Access Compliance Report

Public Rights-of-Way

(Curb Ramps)

Intersection ID: 10040846	Main Street: WAKEFIELD_DR	Cross Street: N/A	Location: W
ADA ID: E16F59BD6BFC	Ramp Type: Perp	Initial Pass/Fail: Fail	Overall Compliance: No
Severity Score: 12.5			
Codes/Mitigation Info/Possible Solution		Field Measurements/Component Compliance

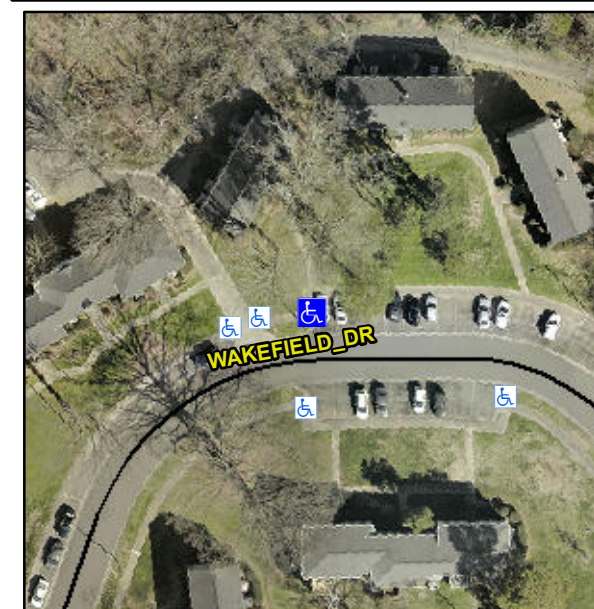
R304.5.3

Compliance	Description	Data	Compliance	Description	Data
N/A	Ramp Length (in)	56.0	Yes	Ramp Slope (%)	5.1
Yes	Ramp Width (in)	48.0	No	Ramp XSlope (%)	6.1
N/A	Flare Type LT	N/A	N/A	Flare Type RT	N/A
N/A	Flare Slope LT (%)	N/A	N/A	Flare Slope RT (%)	N/A
N/A	Flare Traversable LT?	N/A	N/A	Flare Traversable RT?	N/A
N/A	Landing Length (in)	N/A	N/A	DWS Provided?	N/A
N/A	Landing Width (in)	N/A	N/A	DWS Contrast?	N/A
N/A	Landing Slope (%)	N/A	N/A	DWS Length (in)	N/A
N/A	Landing X Slope (%)	N/A	N/A	DWS Full Width?	N/A
N/A	Landing Curb? (Y/N)	N/A	N/A	DWS Offset (in)	N/A
N/A	Shared Landing?	N/A			
N/A	Gutter Ponding?	N/A	N/A	Gutter Slope (%)	N/A
N/A	Gutter Lip Ht (in)	N/A	N/A	Gutter X Slope (%)	N/A
N/A	Painted X Walk1?	No	N/A	Painted X Walk2?	N/A
	X Walk 1 Direction	To E		X Walk 2 Direction	N/A
N/A	X Walk 1 Width (in)	N/A	N/A	X Walk 2 Width (in)	N/A
	X Walk 1 Slope (%)	8.1		X Walk 2 Slope (%)	N/A
	X Walk 1 X Slope (%)	1.4		X Walk 2 X Slope (%)	N/A

Remove & Replace Entire Ramp.
